A meeting of the **WAVERLEY DEVELOPMENT ASSESSMENT PANEL** will be held on Level 3, Waverley Council Chambers, Cnr Bondi Road and Paul Street, Bondi Junction at:

AGENDA

WDAP-1802.1 **PAGE 4** **1 Kippara Road, DOVER HEIGHTS – Alterations and additions including a roof terrace (DA-487/2017)**

Report to the Waverley Development Assessment Panel

Figure 3: East elevation of subject site viewed from the upper floor front western bedroom of 15 Loombah Rd, Dover Heights being the adjoining premises across the the road to the east.

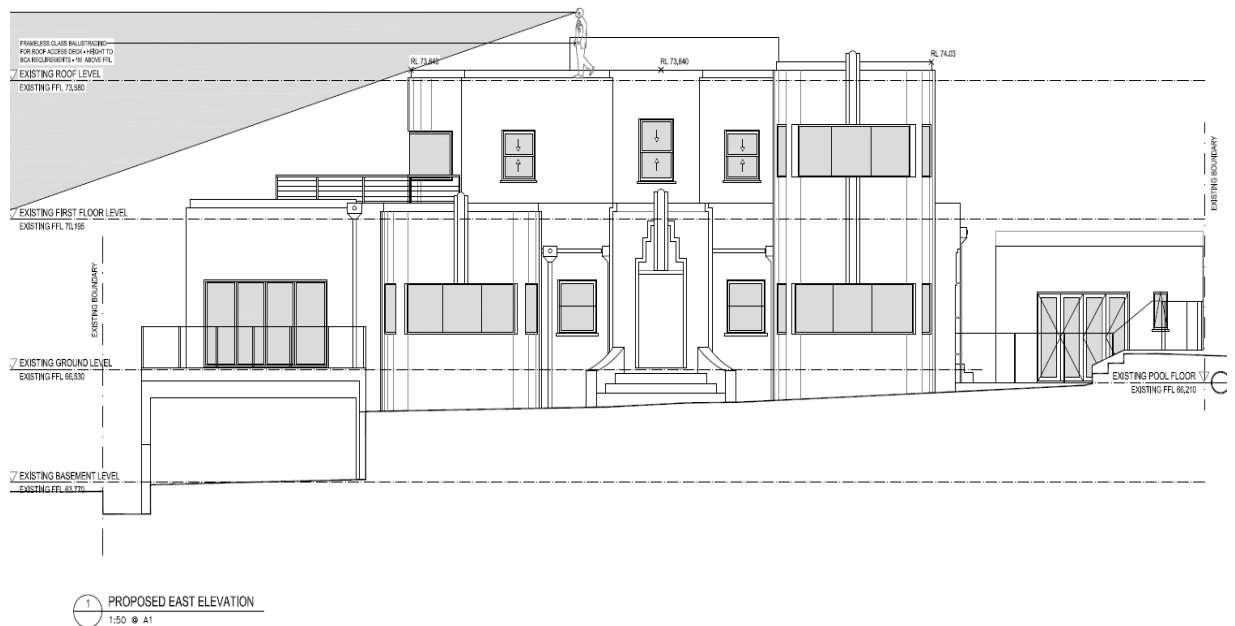
- The proposal does not change the overall building height of the dwelling house as it does not change the floor levels and parapet height of the dwelling.
- The overall building height of the dwelling is compatible with that of other dwellings in the vicinity of the site.
- No additional overshadowing caused by the proposal.
- The building height variation will not affect views as the balustrade is clear glass.
- The proposal maintains the building bulk and scale of the dwelling house.
- The proposal will not result in adverse streetscape impacts.
- The variation will not compromise the intent of the development standard as it satisfies the relevant objectives of the development standard. The proposal is therefore in the public interest.

The variation of the height of buildings development standard is generally well founded on the basis of the variation causing minimal environmental impact on adjoining properties and the wider locality and its consistency with relevant objectives of the R2 zone and objectives of the height of buildings development standard.

STAGE:	ROOF ACCESS CONCEPT
DRAWING NAME:	PROPOSED ROOF PLAN
DA (A1)

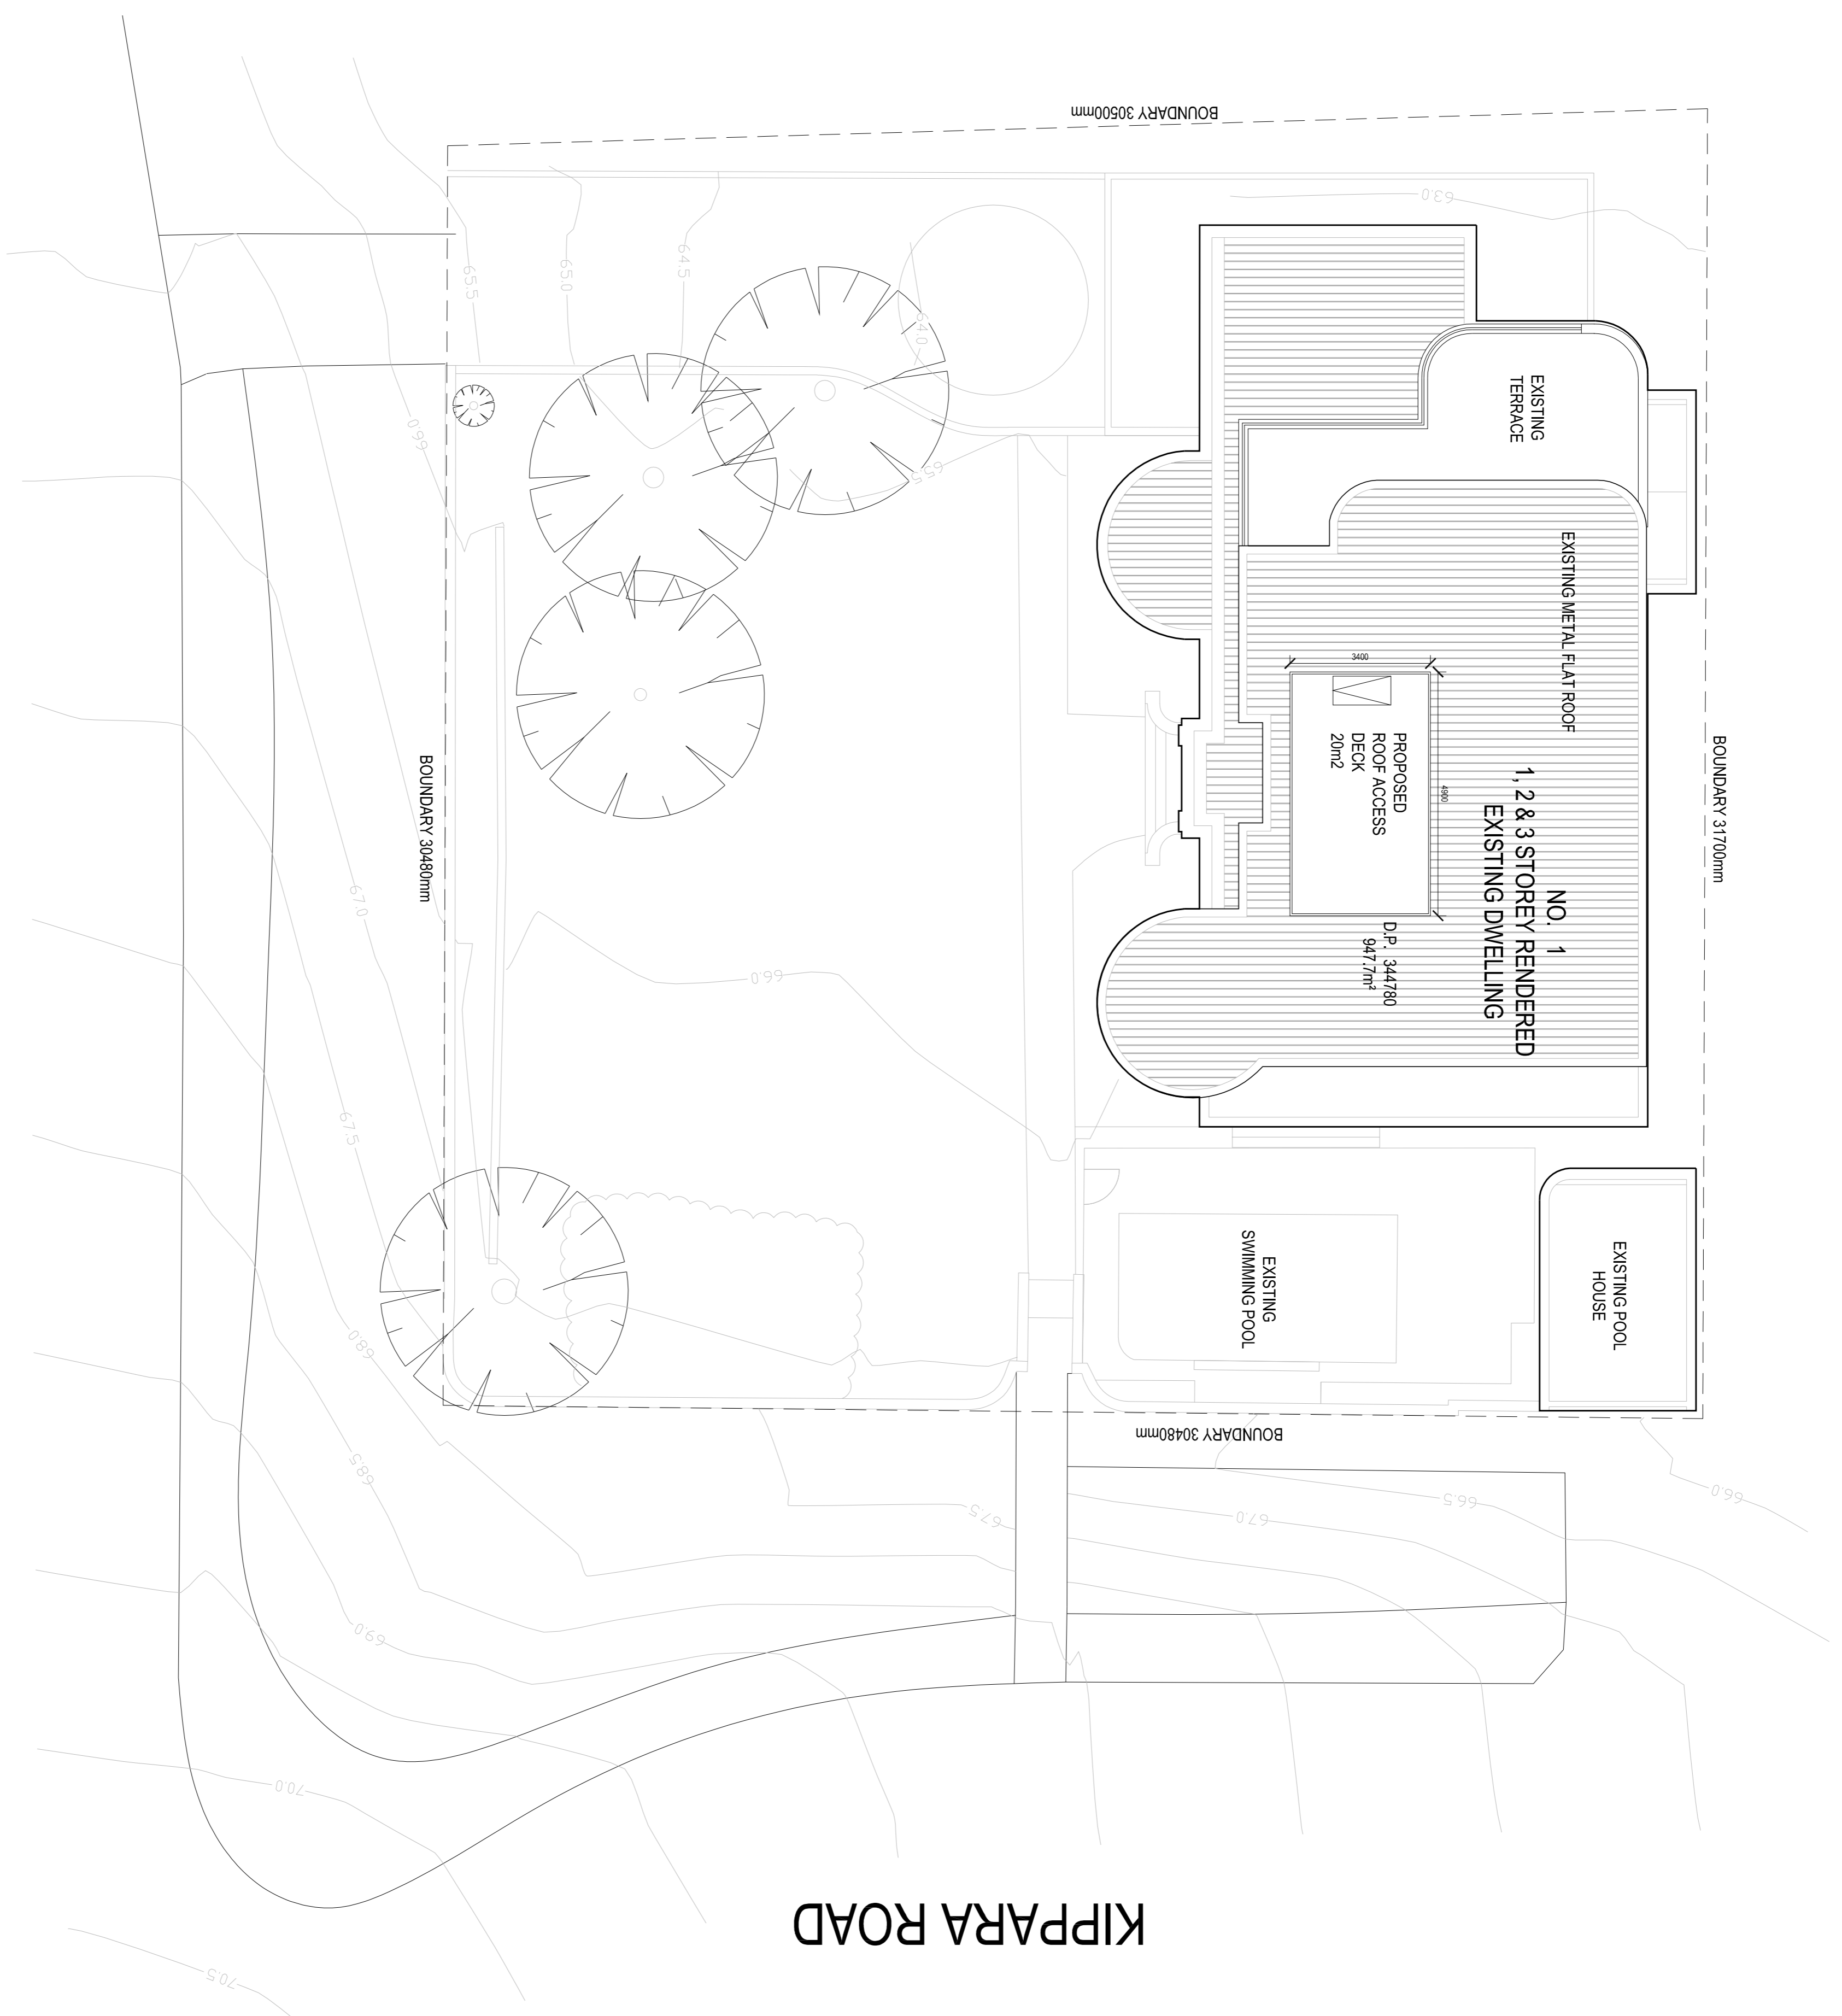
The proposal includes a roof top terrace comprising a trafficable area of 20m². Roof terraces are generally discouraged in the Waverley local government area, however small roof terraces may be appropriate, particularly in Dover Heights. Planning control (e) under section 1.8 of Part C1 of Waverley DCP 2012 sets out circumstances where roof terraces are appropriate, which are extracted as follows:

- a) The proposed roof top terrace is to be limited to a maximum area of 15m² to comply with the Waverley Development Control Plan 2012. In this regard the dimensions of the roof top terrace are to be 4.90m by 3.06m with the maximum RL not exceeding 74.84.
